Staff Report & Recommendation

Historic Preservation Board

**SUBJECT:** HPB25-0679, 100 Lincoln Road-The Decoplage

An application has been filed requesting a Certificate of Appropriateness for the partial demolition of the existing portecochere and associated site and groundfloor construction, and for the renovation of the portecochere together with associated site and groundfloor improvements, including variances from the maximum encroachment into the rightofway, the maximum frontage allowed along a primary elevation, and the maximum height permitted for a porte-cochere

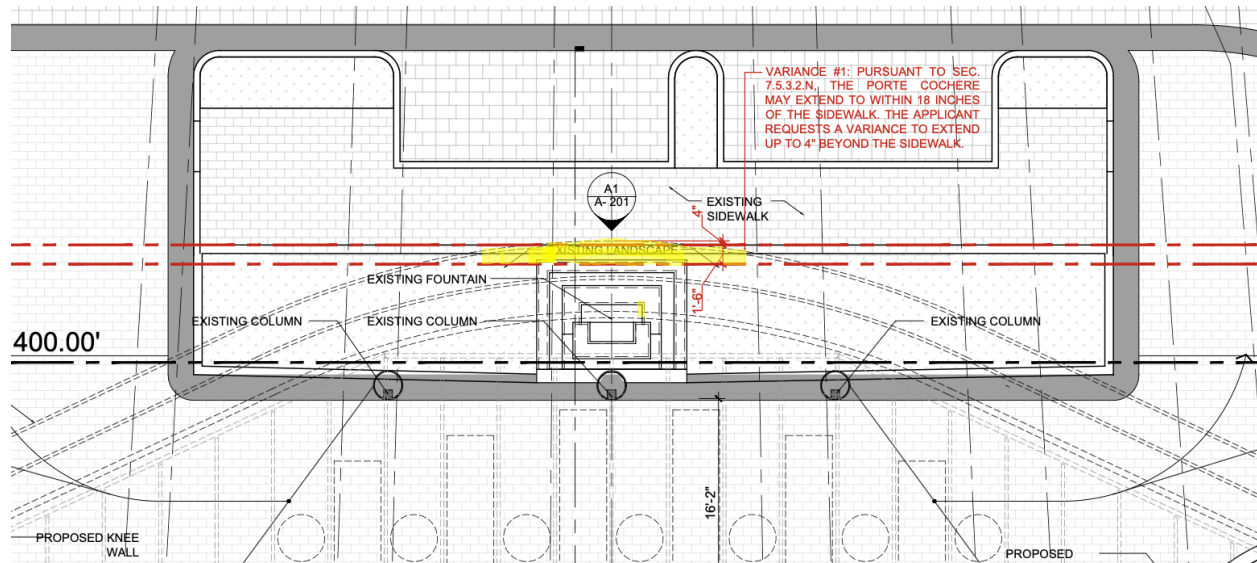
Note: The area highlighted in yellow in the above diagram represents the extent of Variance #1, which is for only a relatively small portion of the porte-cochere.

The applicant is requesting a variance in connection with the renovation of the existing porte-cochere and associated ground-floor and site improvements. Pursuant to the applicable regulations, a porte-cochere may extend from an entry door toward the street line; however,

where a sidewalk or curb is present, the structure is required to maintain a minimum setback of 18 inches from the sidewalk. The requested variance is associated with the retention of the existing structure, and the proposed serpentine stepped treatment along the edge of the porte-cochere. Due to the practical difficulties associated with the proposed renovation project and the minimal extent of the requested Variance #1, as shown in the highlighted diagram above, and its association with the retention of the existing structure, staff has no objection to the requested variance.

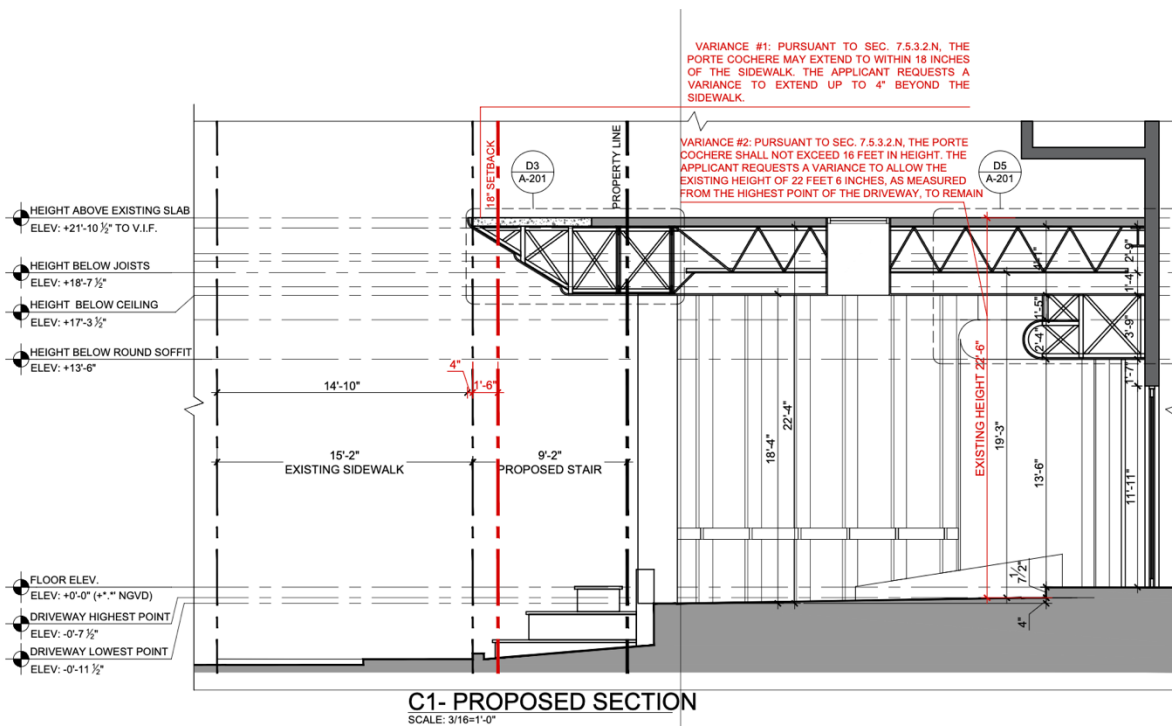
Note: The above section shows the partial extent of Variance #3 (called out by the applicant's plans as Variance #2), and its direct small extension of the existing canopy, maintaining the existing structure, and the current height of 22'-6\".

The applicant proposes to renovate and extend the existing porte-cochere to match its current nonconforming height of 22'-6", exceeding the 16'-0" maximum. The request does not introduce additional vertical massing beyond what currently exists; rather, it allows for the horizontal extension of an existing nonconforming condition, as illustrated in the section diagram above.

The elevation changes between the driveway, ramp, and finished floor require vertical clearance to safely accommodate vehicular access and pedestrian entry. Enforcement of the 16-foot limit would result in clearances incompatible with existing grading conditions and would restrict access for a range of vehicles, including service and emergency vehicles. The proposed height is the minimum necessary to address these conditions while maintaining safe and functional operations beneath the structure. Accordingly, staff is supportive of Variance #3.

- b. The porte-cochere height shall not exceed 22'-6" as measured from the highest point of the driveway, consistent with the existing nonconforming structure. No increase in height above the existing structure shall be permitted.
